Engineering Design Standard Section 4-1

## ADDENDUM TO BUCKEYE SEWER DESIGN STANDARDS

Request No. <b>1</b>	APPROVED: Y / N	ADDENDUM NUMBER <u>S1</u>
----------------------	-----------------	---------------------------

**Revised Standard Number:** Revise Detail 41260

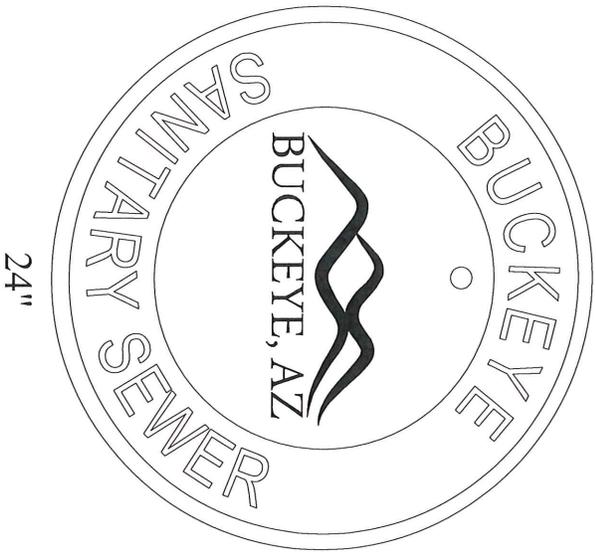
The original detail 41260 depicts the saddle logo. That logo was changed into the new current logo. This addendum will bring the logo up to current standard.

Revised detail 41260 to the current logo.
